Mop Service Basins

Shop Drawing Submittal Review

Project Name: Webster University-**ISB**

SPEC SECTION: 22 4216.16
Commercial Sinks

MS-1 MOP SINK PER ADDENDUM #2-1

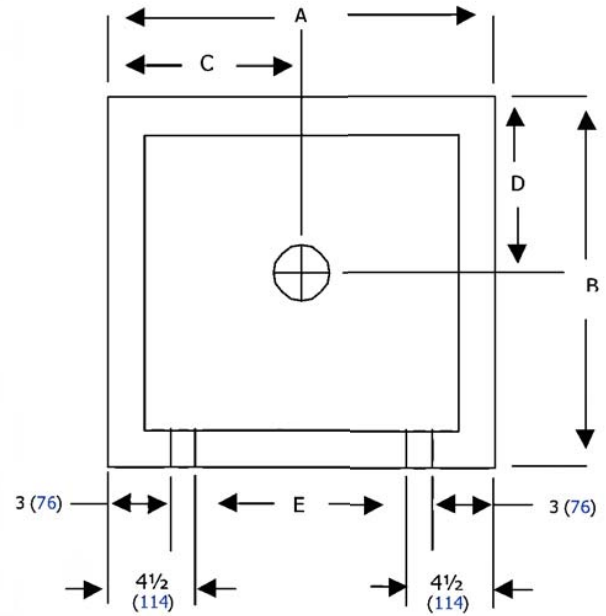
X					Supply Risers BrassCraft Model 1-12AC	
	X				Escutcheons Proflo Model PFE7	Escutcheons are specified to be cast brass. Refer to specification section 220518.
Sink SK-3						
					Fixture	Sink is integral with the countertop. Coordinate with architectural drawings.
X					Faucet Chicago Faucet Model 786-GN2BVBE3-2ABCP	Provide under counter waste and supply protective piping covers as required. Verify requirements with the architectural drawings.
X					Drain Assembly Elkay Model LK35	
X					P-Trap Proflo Model PFPTB403	
X					Angle Stops BrassCraft Model SCR19XC	
X					Supply Risers BrassCraft Model 1-12AC	
	X				Escutcheons Proflo Model PFE7	Escutcheons are specified to be cast brass. Refer to specification section 220518.
Mop Sink MS-1						
X					Fixture Fiat Model TSB-3000	
X					Faucet Symmons Model S-2490	
X					Hose Bracket Proflo Model PF296	
X					Hose Proflo Model PFSSHE	
X					Mop Bracket Proflo Model PF245

X					Wall guards Proflo Model PFWG24S	
Kitchen Sink KS-1						
	X				Fixture Elkay Model ECTSR25229BG	Cut sheet indicates 3-hole punch – verify this with faucet 4-hole punch requirement
X					Faucet Chicago Faucet Model 1102-202358AB
